CHANGES AND ADDITIONS TO
PARTS BULLETINS 1064B, ISSUE 2 AND 1080B, ISSUE 1
SINGLE MAGNET REPERFORATOR
(MODELS 14 AND 20 NONTYPING)

III252 FILTER ASSEMBLY
(EXCLUDES PARTS MARKED (A))

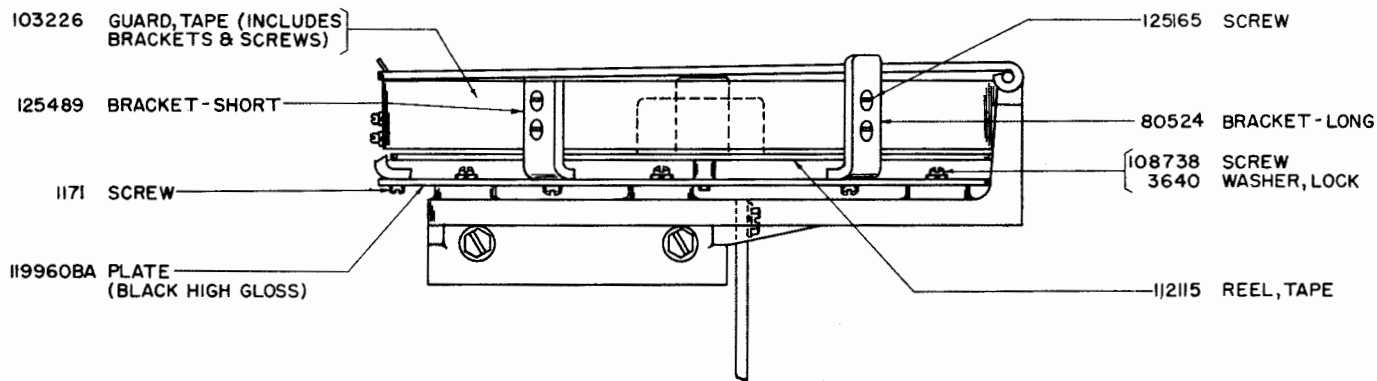
The 92229 line relay radio filter assembly has been replaced by 111664 line relay filter assembly and is subject to the following changes:

Delete 74614 resistor

The 61-24 washers-bakelite have been replaced by 75750 washers-fibre.
